Serial No. : 10/604,561
Applicants : Gerald L. Dykstra et al.
Response to Office Action : Mailed From USPTO on 09/09/2005
Page : 7

REMARKS

Appl. No. 10/604,561
Response Dated Jan. 6, 2006
Reply to Office Action Mailed Sept. 9, 2005
Annotated Sheet Showing Changes

Fig 1

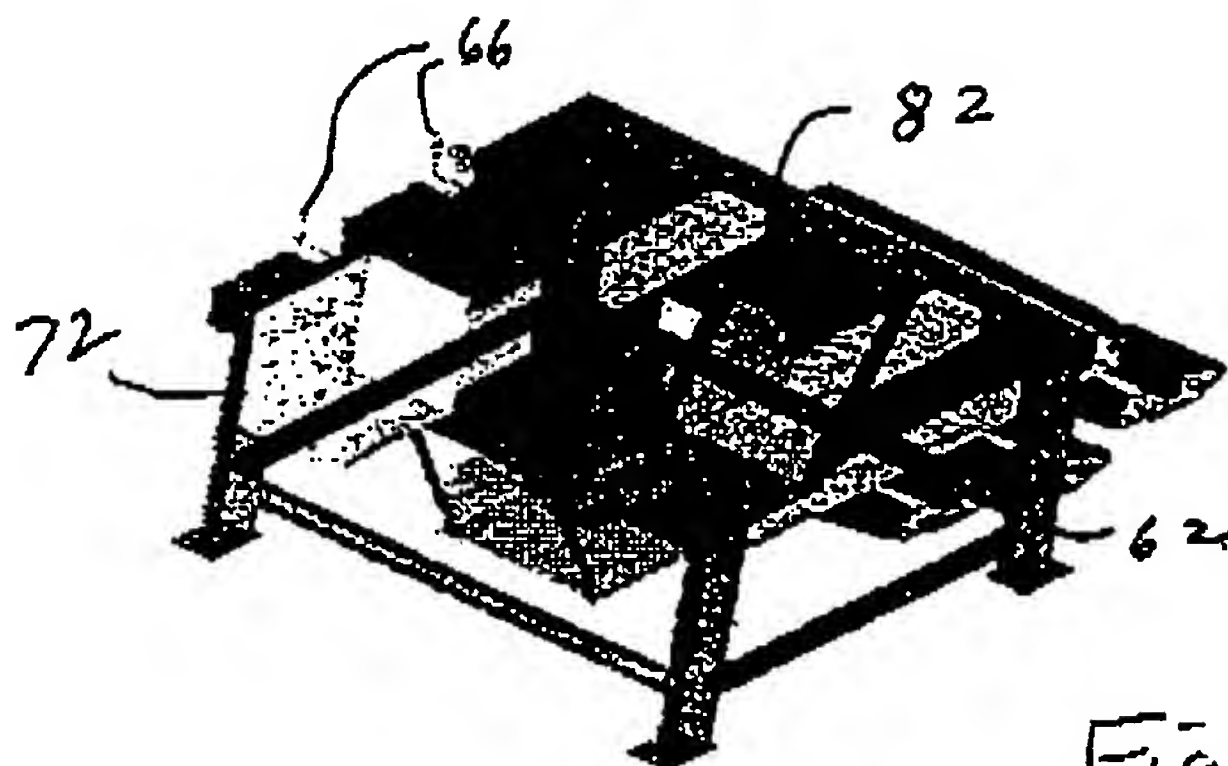
Reference Nos. 34, 36
and 38 added

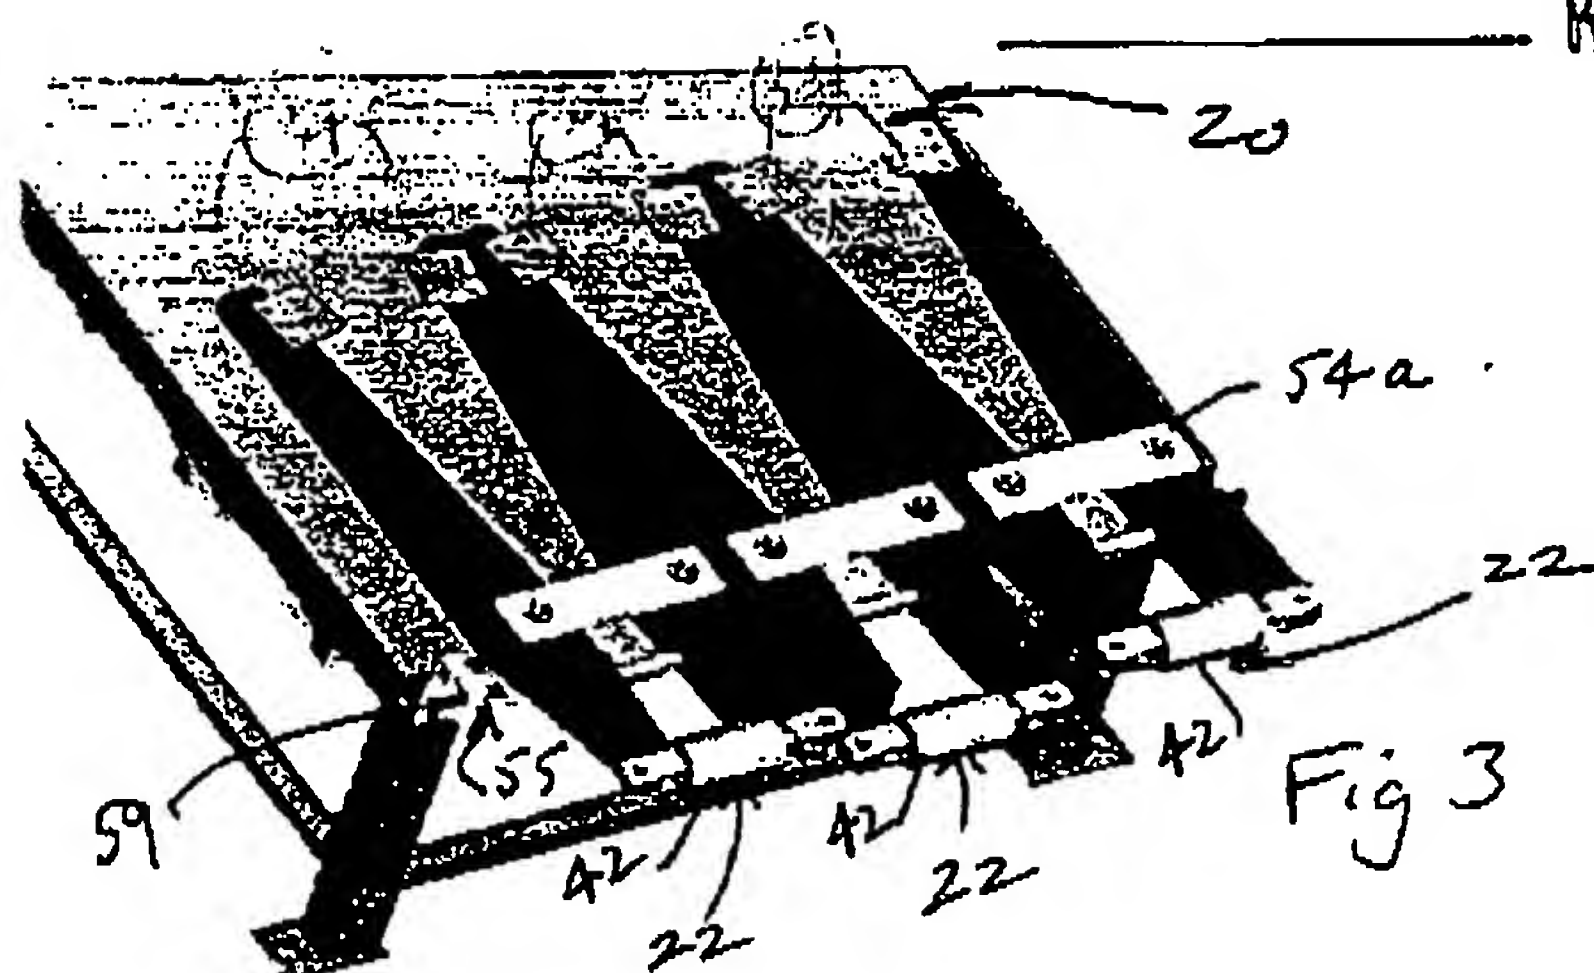
Reference No. 34 added

Fig 5

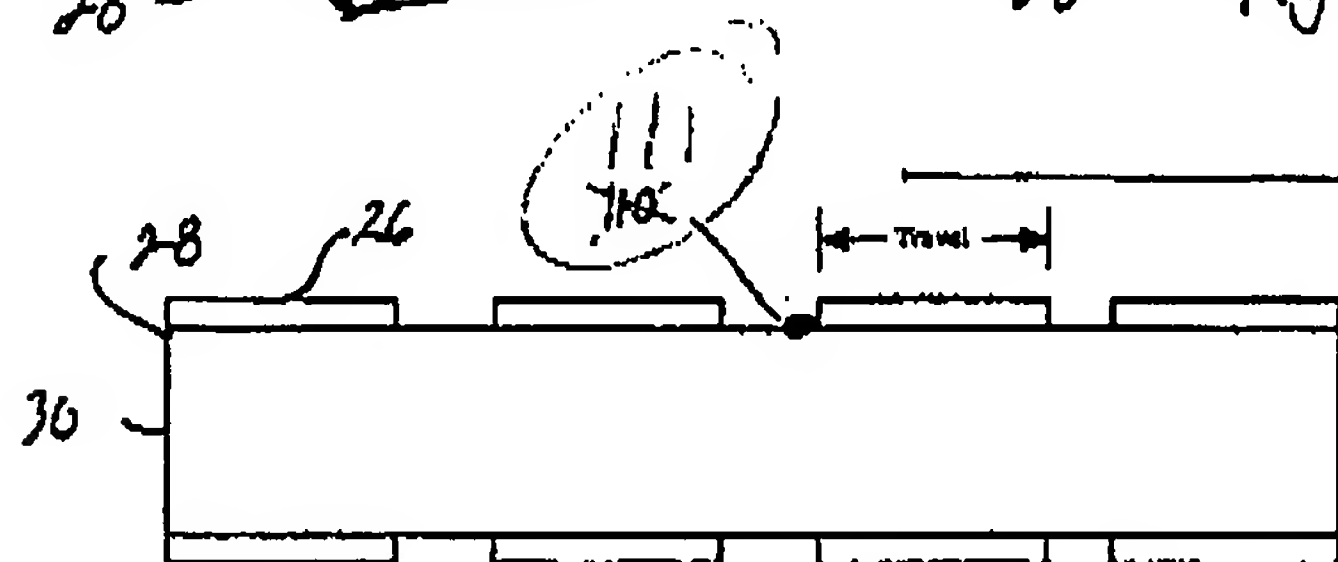
Position of blades 34
raised with respect
to block 32

Fig 15

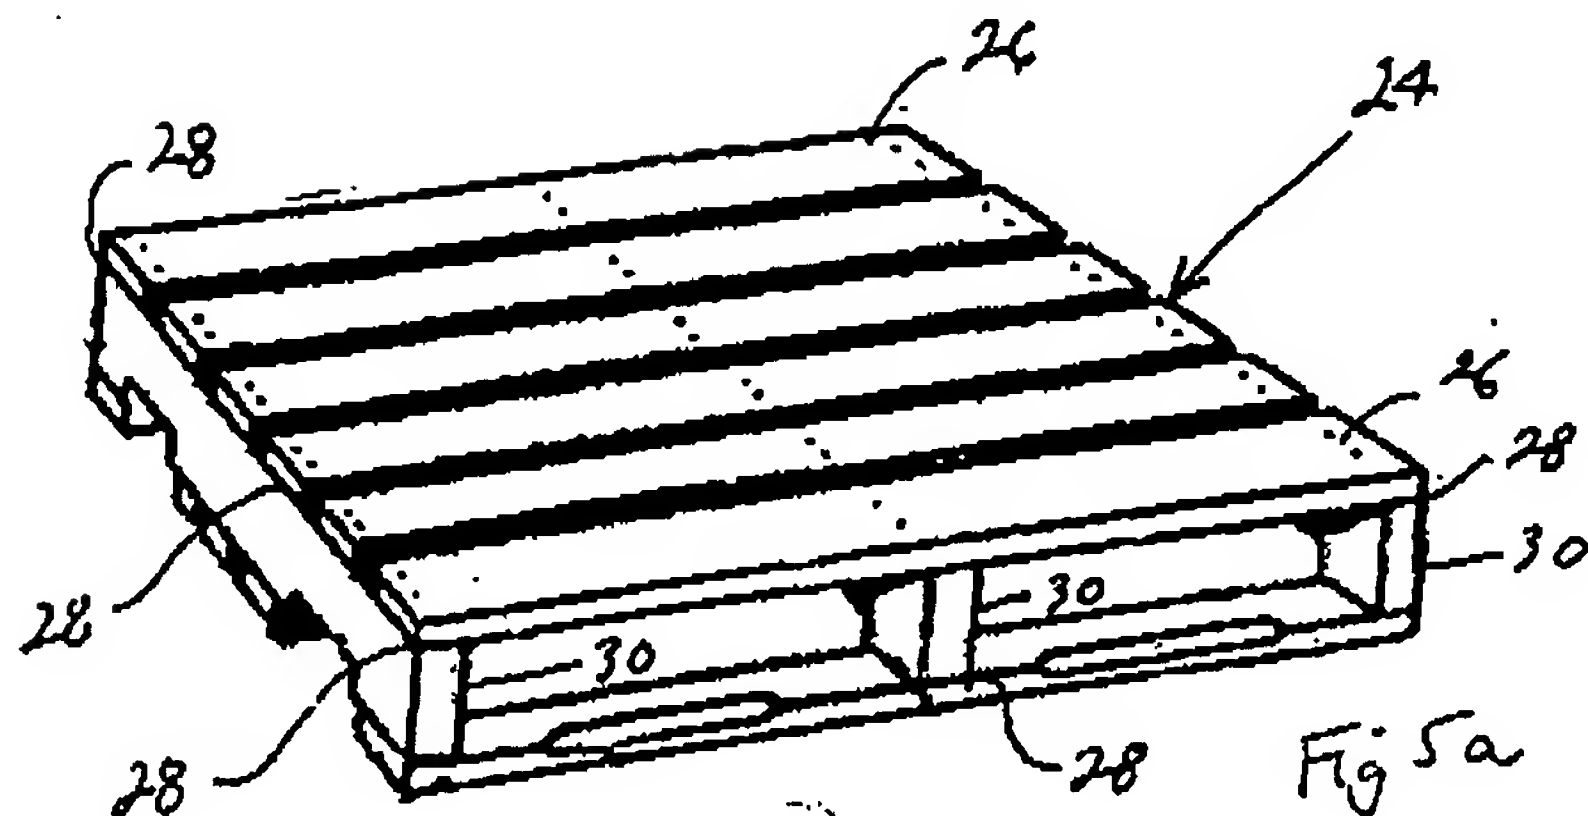
The disclosure is objected to because "diamond wire 110" uses a part number already in use. Paragraph [0031] is amended to change the part number to "111".

Reference No. 110
changed to 111
